Appl. No. 10/642,313 Amdt. Dated January 5, 2006

AMENDMENT TO THE DRAWING FIGURES

Please amend FIG. 5 as indicated on the ANNOTATED MARKED UP DRAWING and on the REPLACEMENT SHEET.

FIG. 5

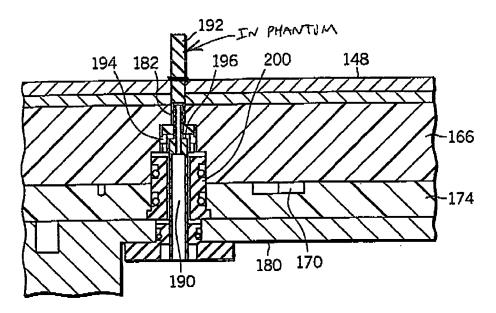
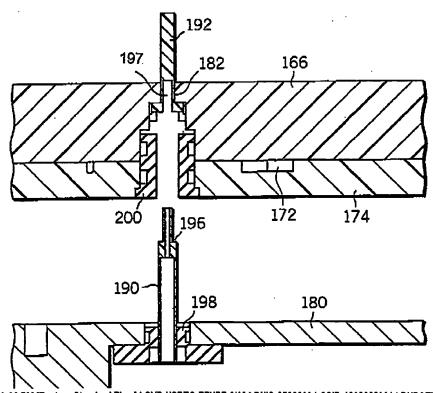
A Notice of Allowance has been issued in this application. The Examiner has required a change to the drawing figures to show the top end of light pin 192 to be flush with the upper surface of the polishing pad. Accordingly, FIG. 5 has been amended to show the top portion of light pin 192, the portion that is subsequently removed, in phantom. The specification has been amended to explain the change in FIG. 5 and to correct a typographical error. No new matter has been added by these amendments. The required changes having been made, it is believed that the application should now proceed to issue.
